APA TO FC  
INTERFACE  
DRAWING

Rev to APA Double Stack Interface Drawing

APA TO FC  
INTERFACE  
DRAWING

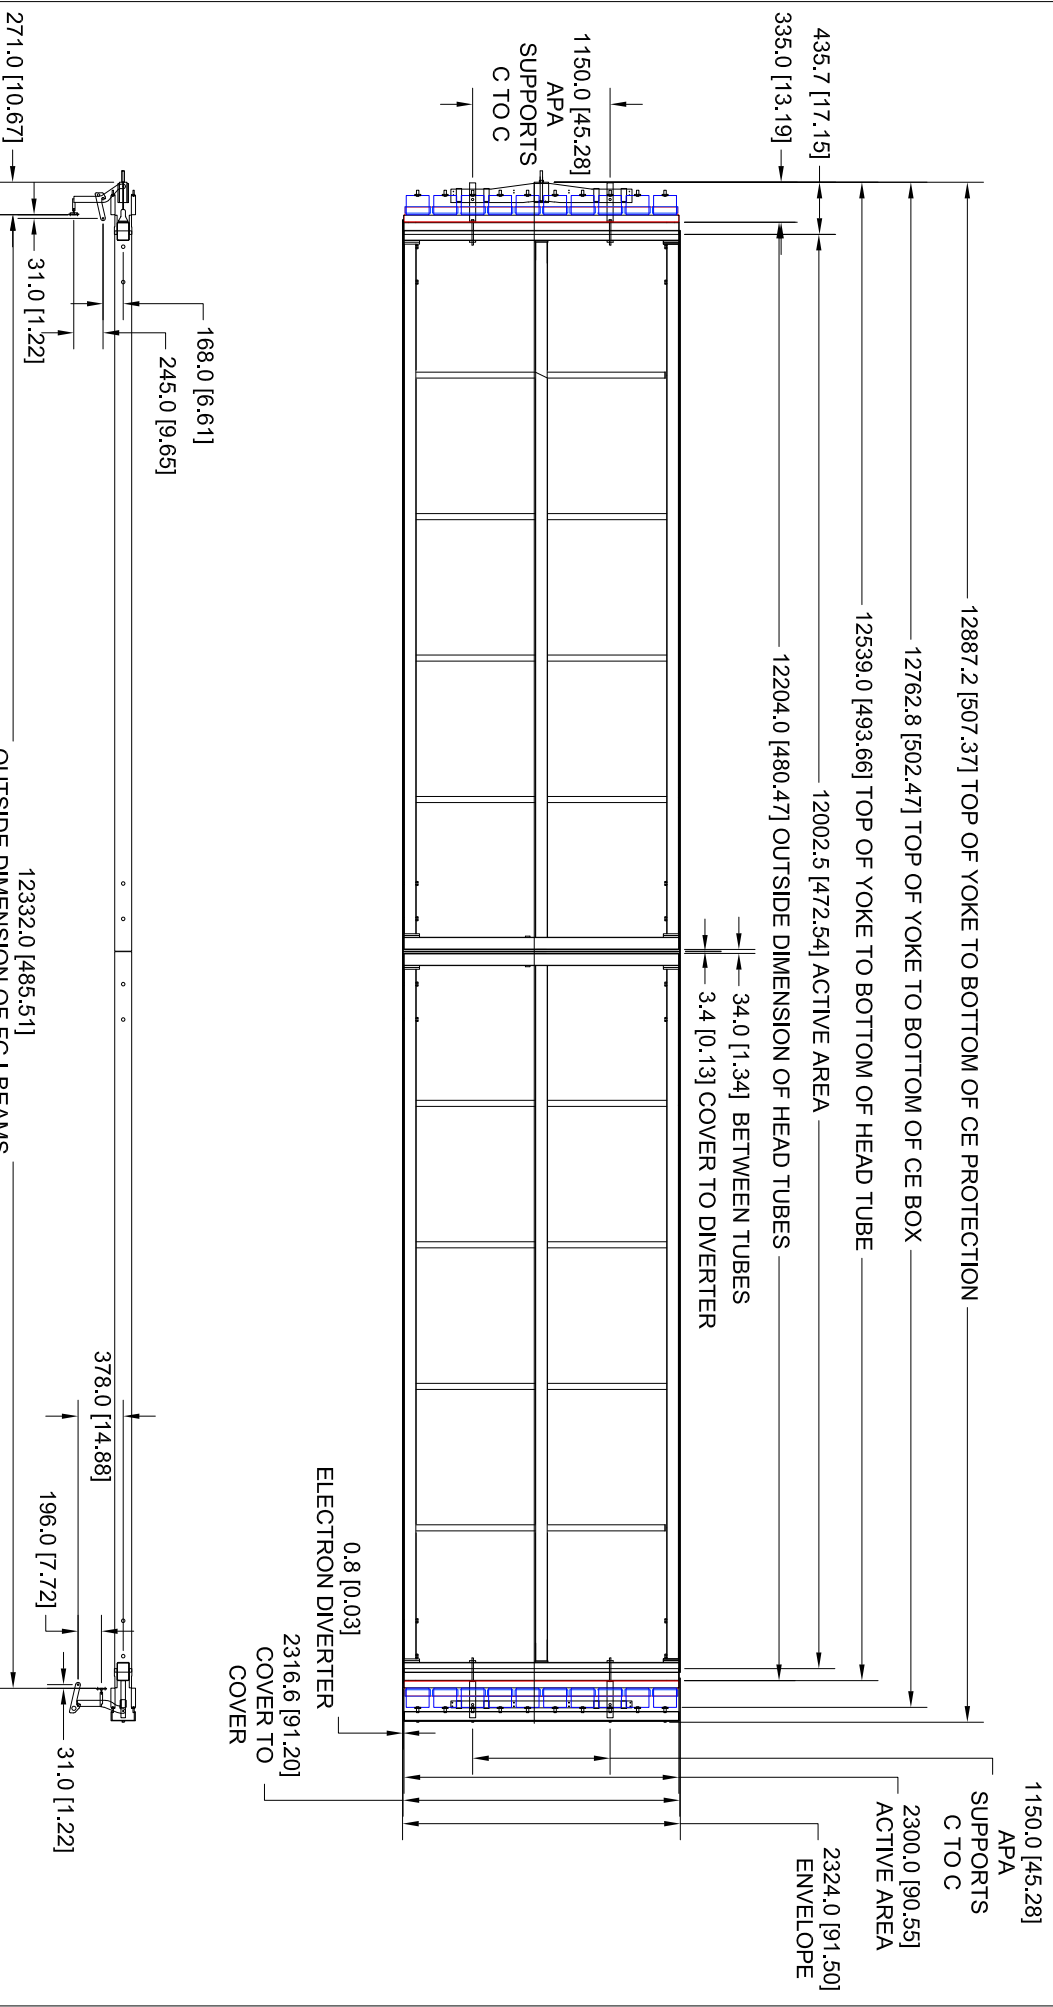
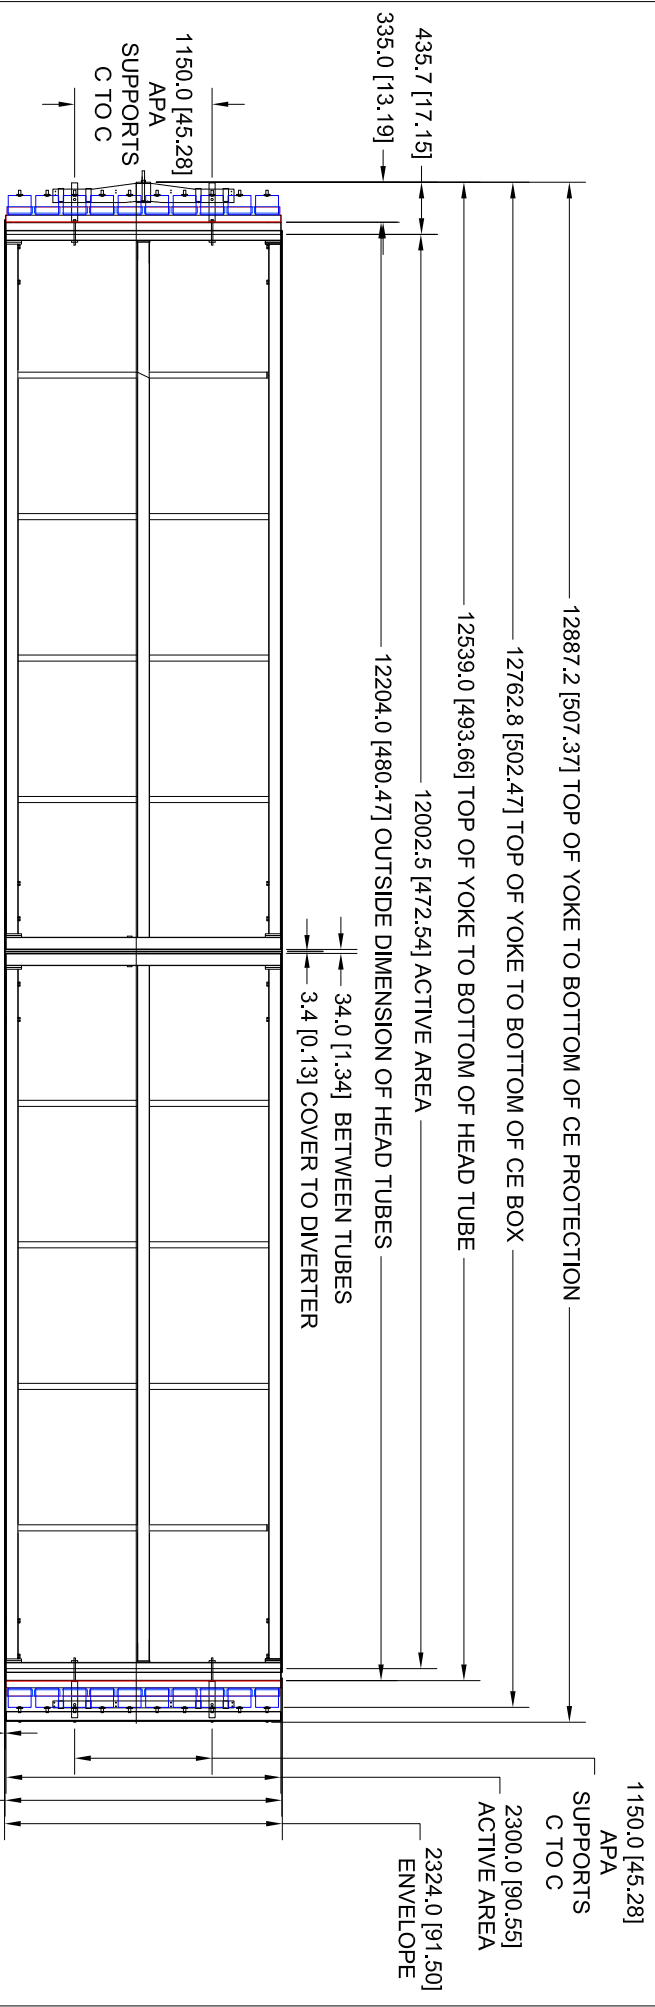
168.0 was 187.0 (Latch was shifted 12.7mm out of position)
